Windfarm committee report

Kyllachy Wind Farm – application under Section 36 of the Electricity Act 1989 for the construction and operation of a windfarm and energy storage facility within the Planning Authority of the Highland Council, of 13 wind turbines, with a maximum blade tip height of 180m, Battery Energy Storage System (BESS) and associated infrastructure.

Reference: ECU00005153 (CNPA ref. 2025/0240/PAC)

Recommendation: No Objection

Appendix 1 – Kyllachy Wind Farm: Proposed windfarm ZTV

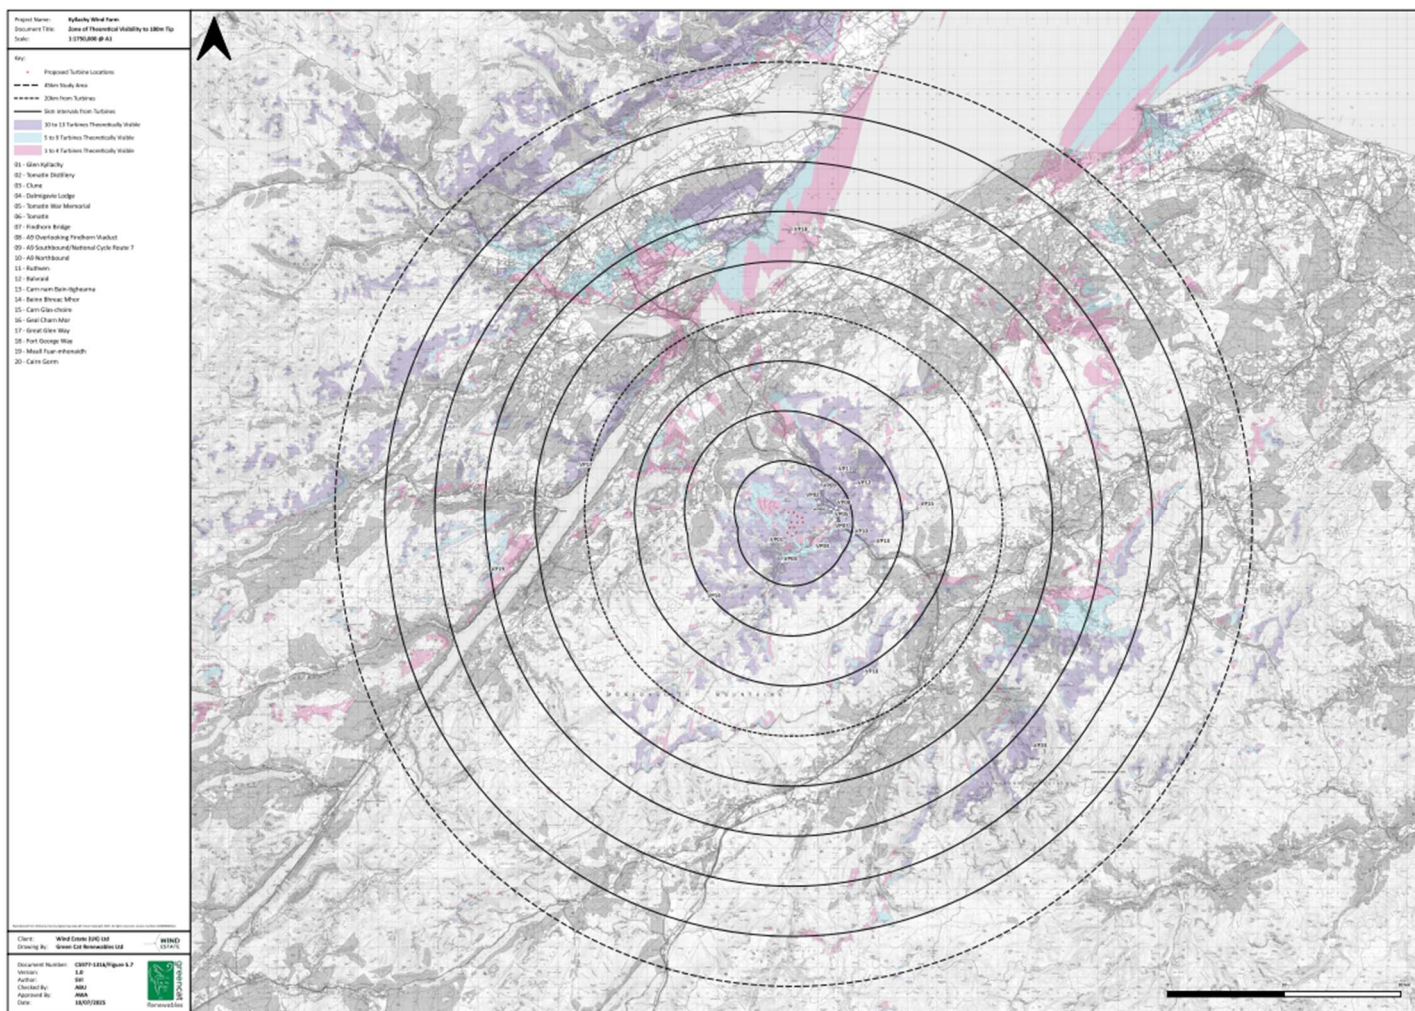
6. Theoretical visibility of the proposed windfarm from within the National Park is shown by the applicant's EIAR figure 5.7 (**Appendix 1**). When considering cumulative visual effects, the applicant's Figure 5.12 Cumulative Basemap (**Appendix 2**) shows the proposed windfarm within the context of operational, consented, in planning and in scoping windfarms within a 45km study area. The blue areas show operational windfarms and, in particular, the proximity of the proposed windfarm to the adjacent operational Glen Kyllachy Wind Farm. Cumulative assessment has not been supported by cumulative Zones of Theoretical Visibility (ZTVs) including operational, consented or in-planning development for this proposal.

7. Visualisations from four viewpoints were provided in the applicant's EIAR to demonstrate the predicted level of visibility that would be had from within / on the boundary of the National Park – refer to **Appendix 1** (Figure 5.7 Blade Tip ZTV with Viewpoints) for the locations:

- a) VP13: Carn nam Bain-tighearna
 - b) VP15: Carn Glas-choire
 - c) VP16: Geal Charn Mor
 - d) VP20: Cairngorm
8. **Committee members should familiarise themselves with the above visualisations online before the meeting.** The visualisations associated with each view point are available to the public by searching the application documents on the [Energy Consents Unit website](#) for the relevant figures within the EIAR – Volume 2b, Chapter 5.
